2000-1 Addison Circle

1996 Huit-Zollars Correspondence

RE: Addison Circle Phase 1 Public Infrastructure
Transverse Sawed Dummy Joint Spacing

QUORUM

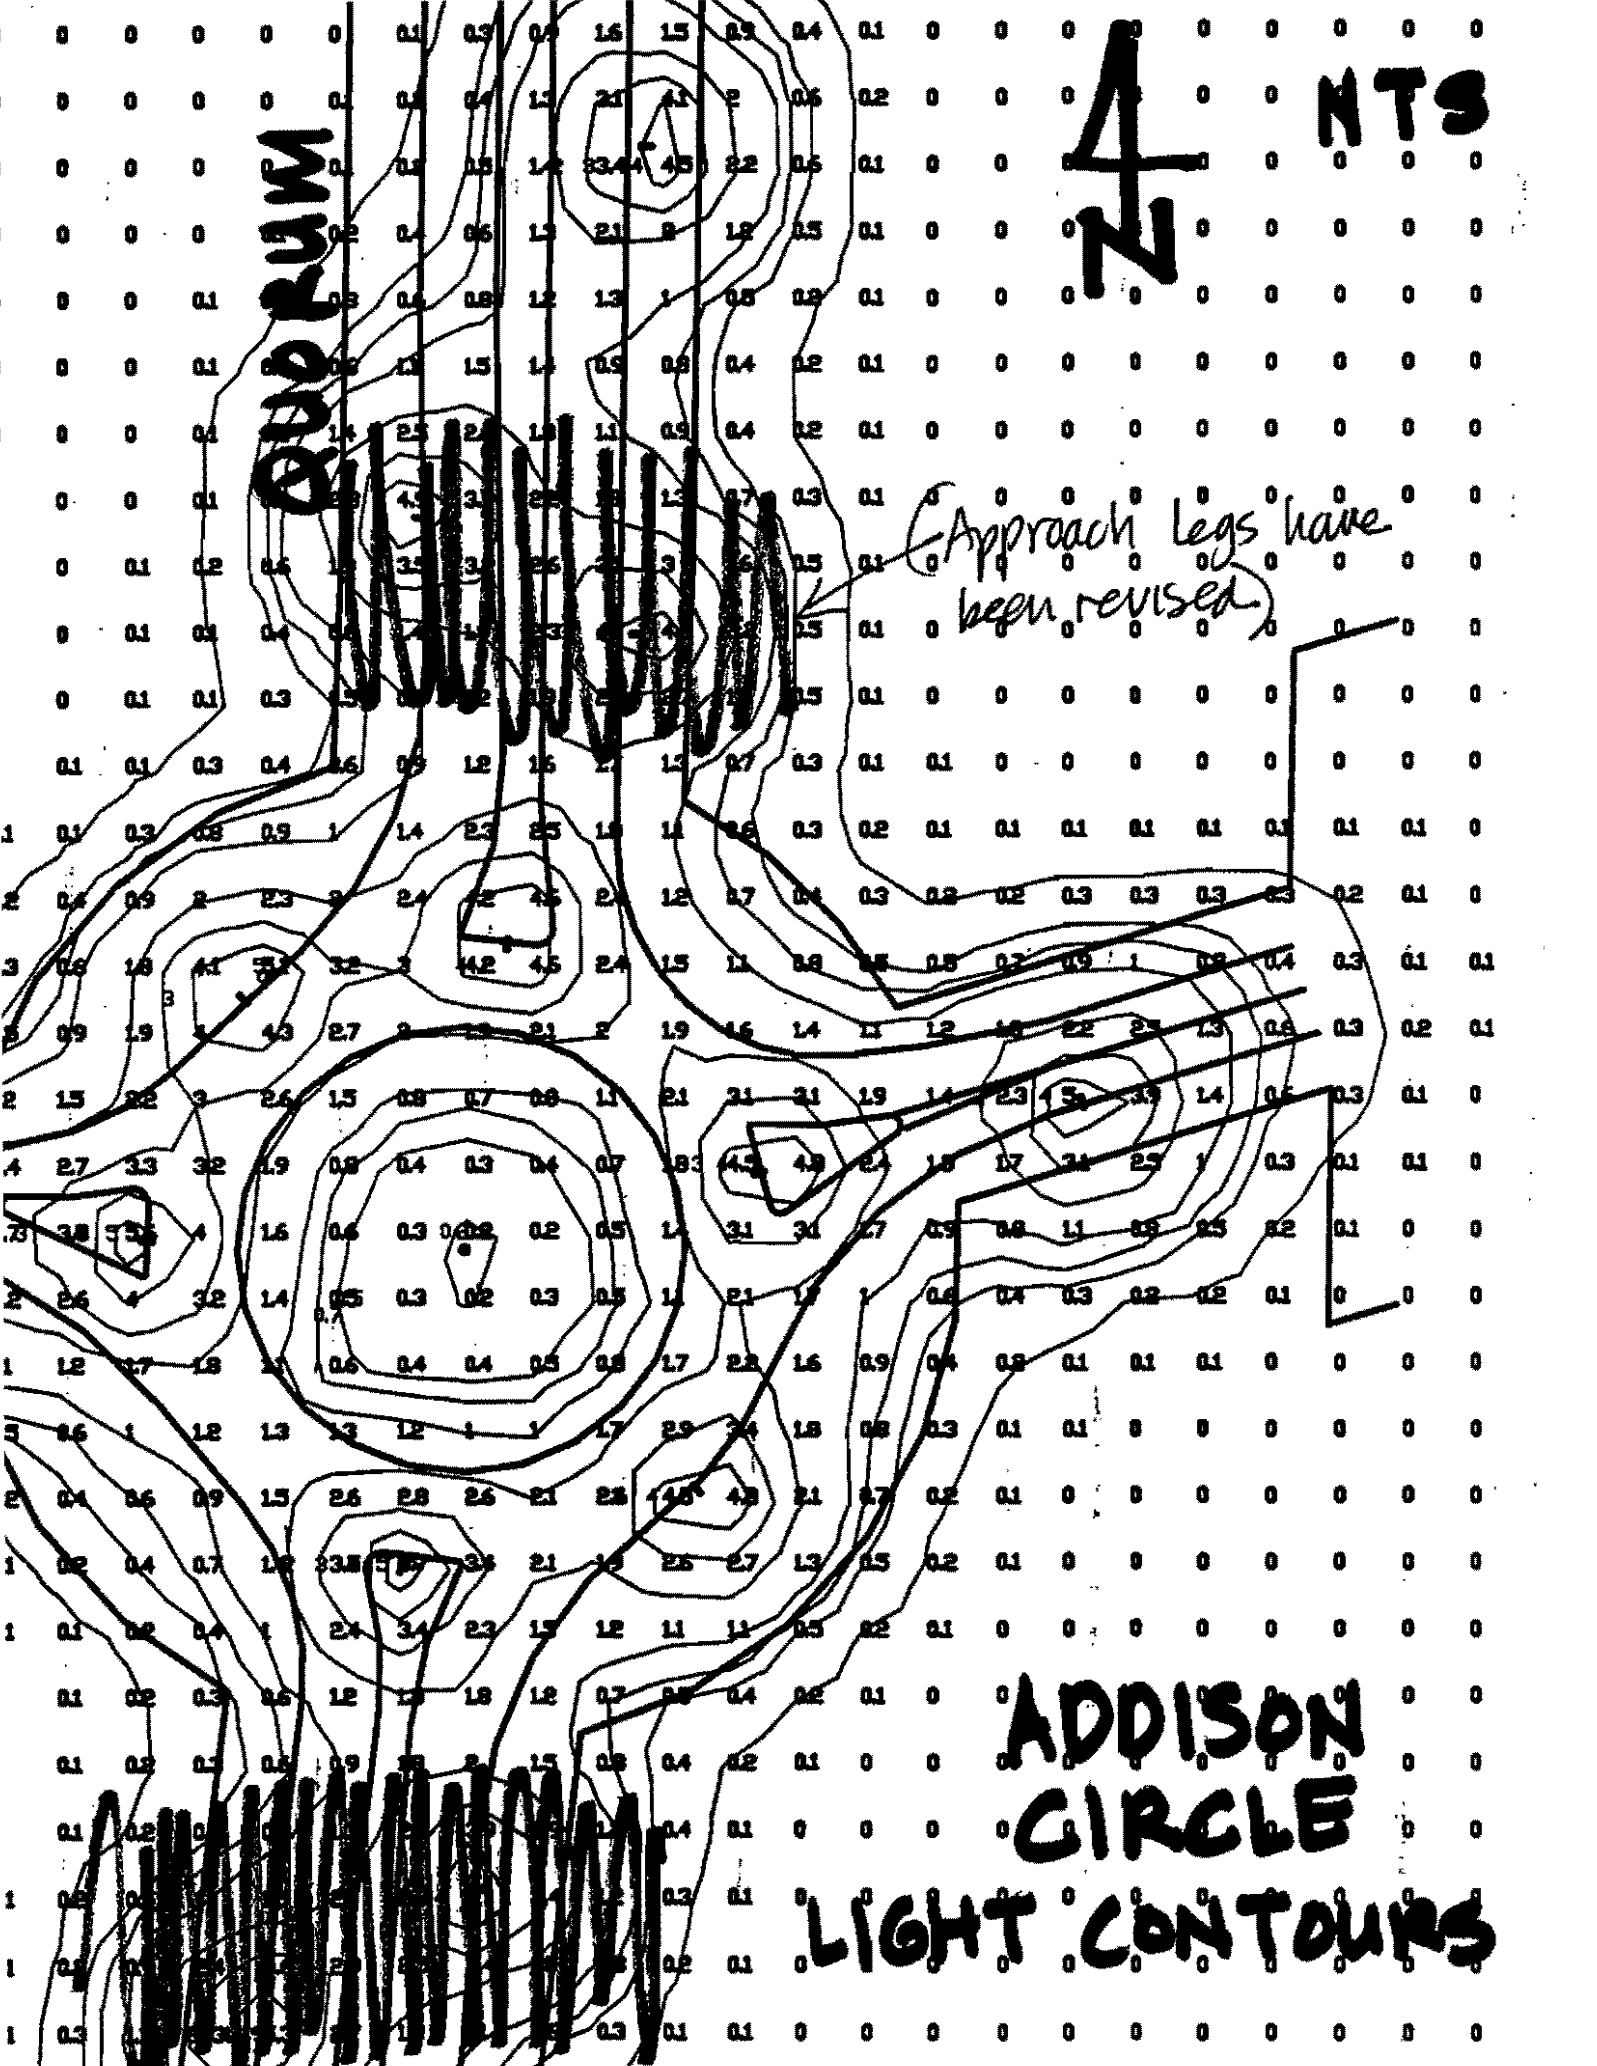
We have no objection to increasing the interior circle's curb height to 10 inches but we agree with the Town that this will provide minimal protection from a runaway vehicle. As I mentioned at the meeting, an additional low (12" to 18") wall set back several feet from the curb would, in combination with the higher curb, provide a better level of protection. Some research would be required to determine the optimum height and location of the wall. This arrangement would further minimize the impact of the signage on the artwork. The decision on raising the curb must be made in the next few days to avoid a delay in construction. The wall analysis is not essential at this time.

(Approach legs have been revised)

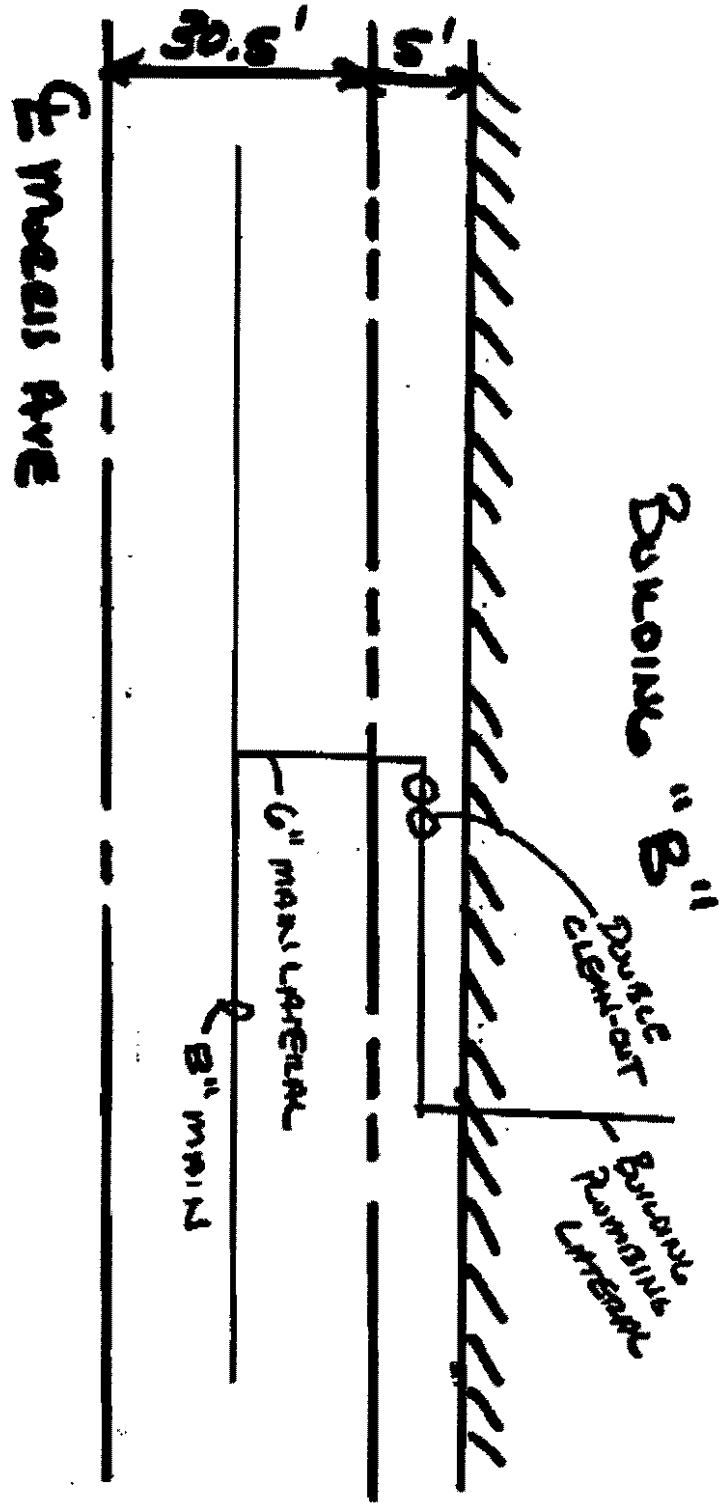
There were three wastewater services on the north side of Building "B" which did not line up with the originally designed location of the public laterals from the main line in Morris Avenue due to a building service design revision after the public infrastructure plans were completed. One of the laterals was addressed by moving a proposed manhole to line up with the service from the building. It was decided that the other two building plumbing lines would have a 90 degree bend (We assume that this will actually be 2-45 degree bends) installed and a portion of the plumbing line run parallel to the building to avoid conflicts with the designed tree and light locations. Once the plumbing line reaches the location of the main lateral another 90 degree bend was installed to connect to the main lateral. This is an acceptable solution to the Town for this particular situation however, the plumbing line which runs parallel to the building appears to be in the public right-of-way which is not acceptable. All private plumbing lines must be installed within the setback zone on private property prior to connection to the main lateral. Morris Avenue has a five foot setback zone for private utilities. As a result Columbus Realty will be required to move two laterals on the north side of Building "B". Per Bruce Ellis with the Town of Addison, the cleanouts may be installed on the parallel section of the line just prior to making the second 90 degree turn into the main lateral. (See attached sketch)

TYPICAL QUADRA DRIVE MEDIAN SECTION
(FULL WIDTH GEARS)

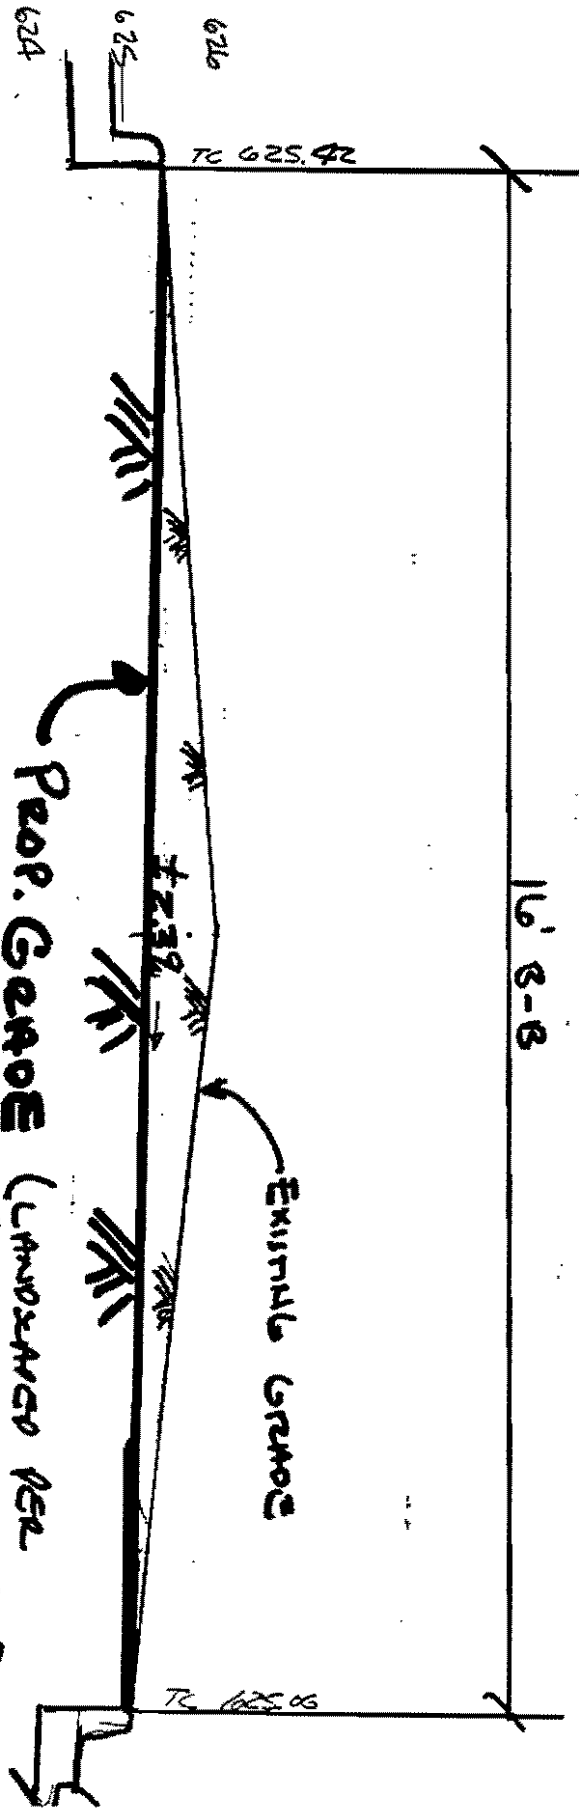
COPIES	DATE	NO.	DESCRIPTION
1		2	ADDISON DRIVE TYPICAL MEDIAN MODIFICATIONS.

EXHIBIT "A"

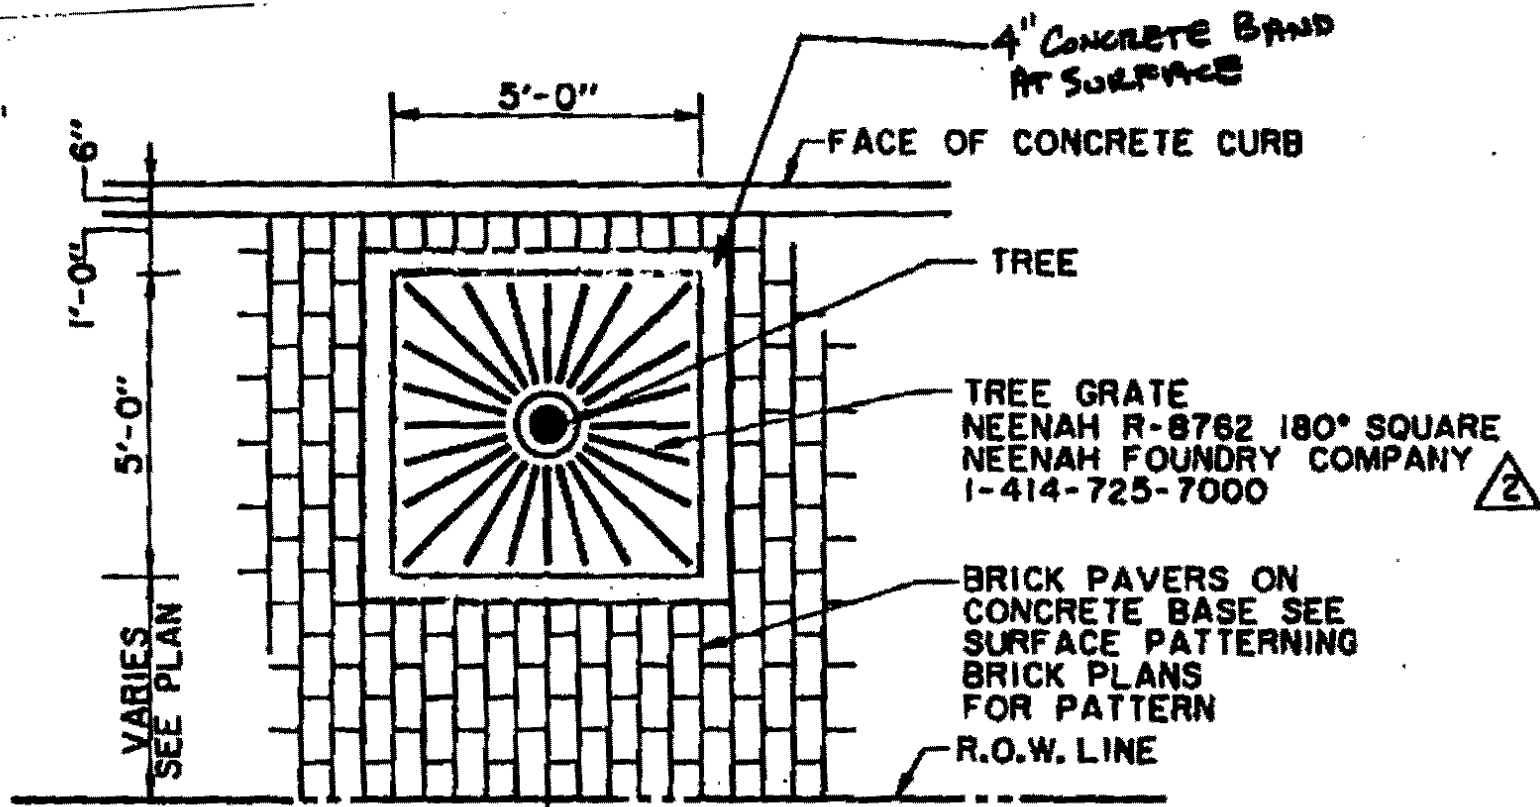
Exhibit "A" shows the tree grate installation as currently designed which illustrates your valid concern that the 1 1/8" x 1 1/2" strip of concrete is not sufficient to provide a stable long term support for the tree grate. The McKimley tree grate, which was originally selected for this project, included a specially designed frame (sheet 56/137) to allow for brick installation to the edge of the grate. The Neenah grate eventually selected for the project did not include a frame to allow for brick installation to the tree grate.

EXHIBIT "C"

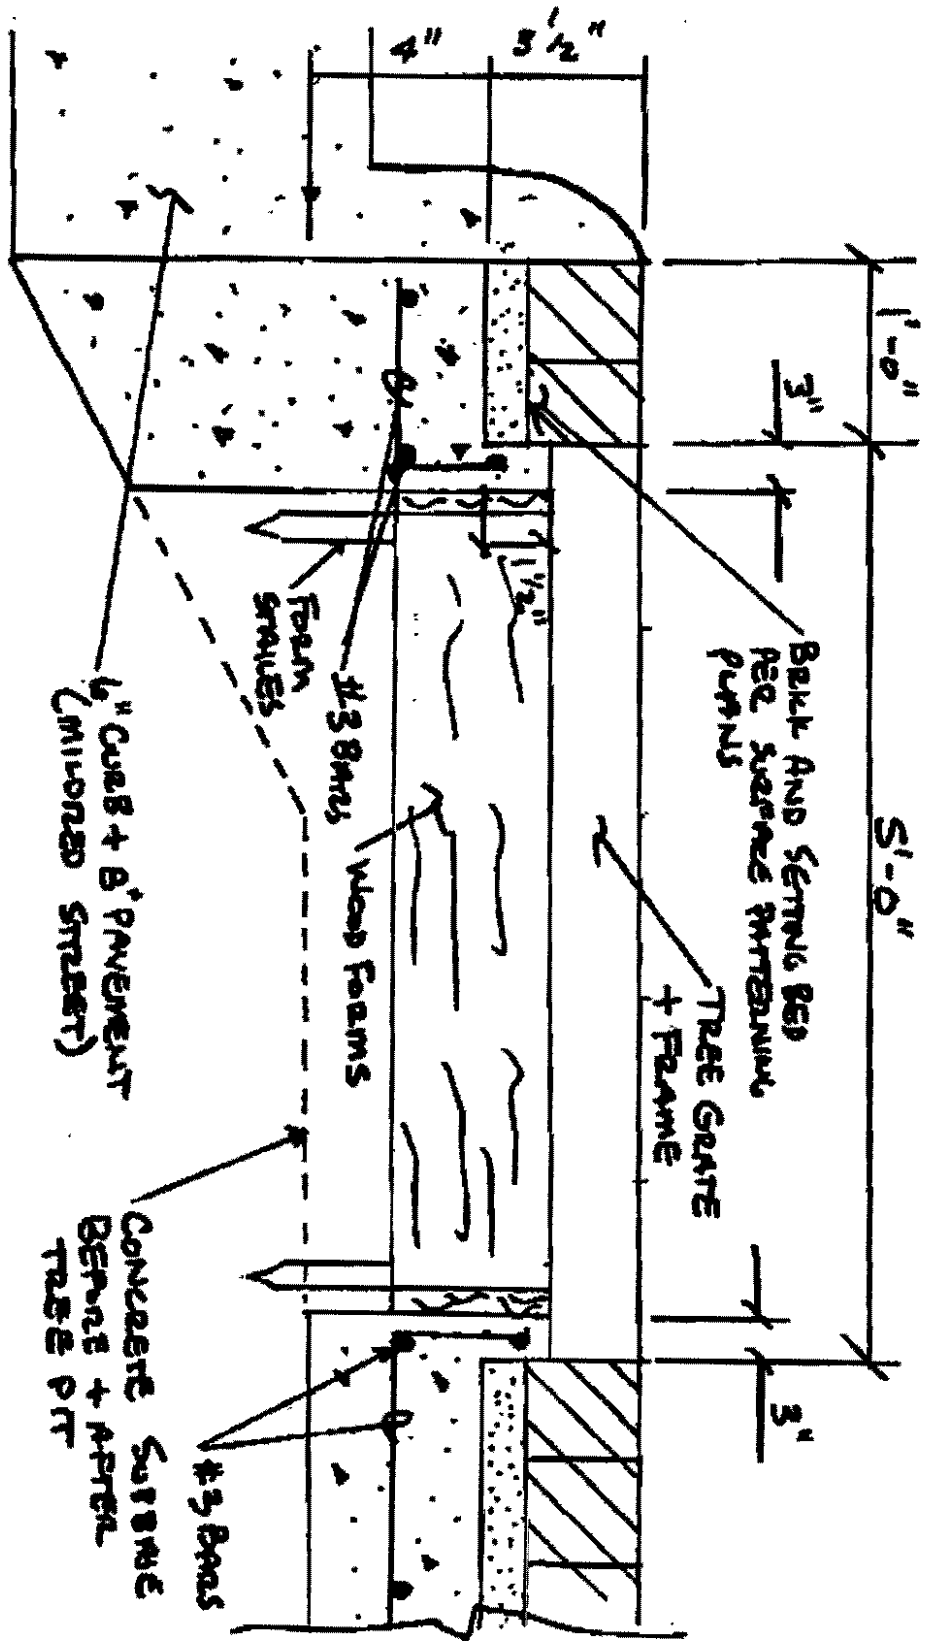
You have requested that a concrete band be poured to the surface allowing for added support which would be a similar installation procedure to that recommended by the manufacturer. We have illustrated your request in Exhibits "B-1" and "B-2". The installation would call for an approximate 4" concrete band around the grate at the surface. Although this installation is acceptable from an engineering perspective, it must still be approved by the landscape architect and Columbus Realty Trust.

EXHIBIT "D-2"

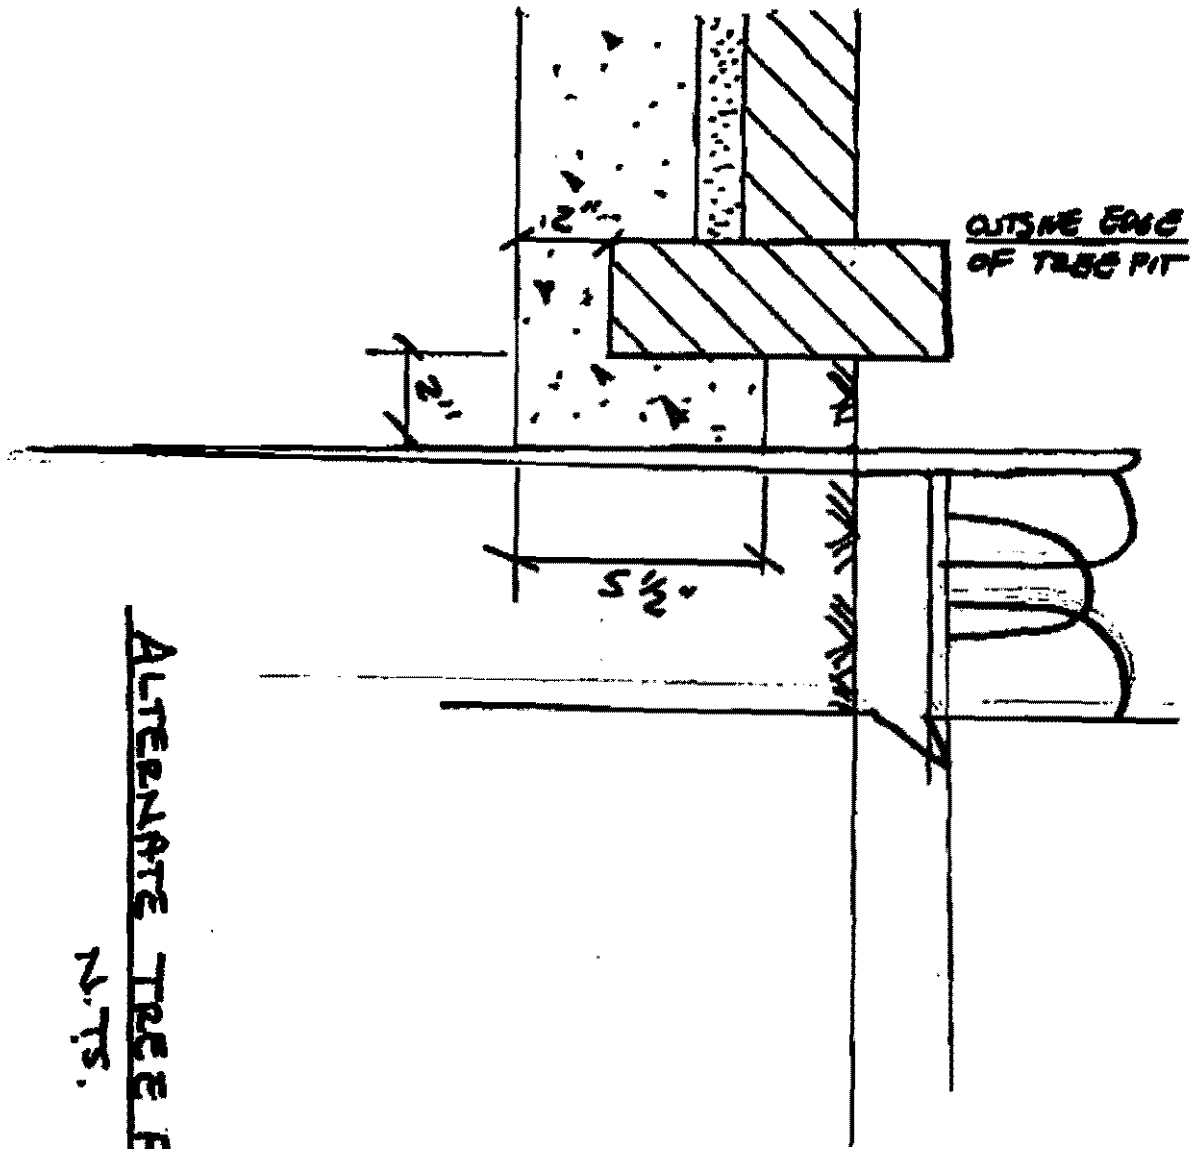
request in Exhibit "D-2". This design is similar to that for the soldier course at the back edge of sidewalk sections of Morris Avenue and McKamy Avenue as shown on sheet 55 of 137. However, this design reduces the planting area from 4' - 5 1/2" to 4' - 1 1/2" for a 200 gallon tree.
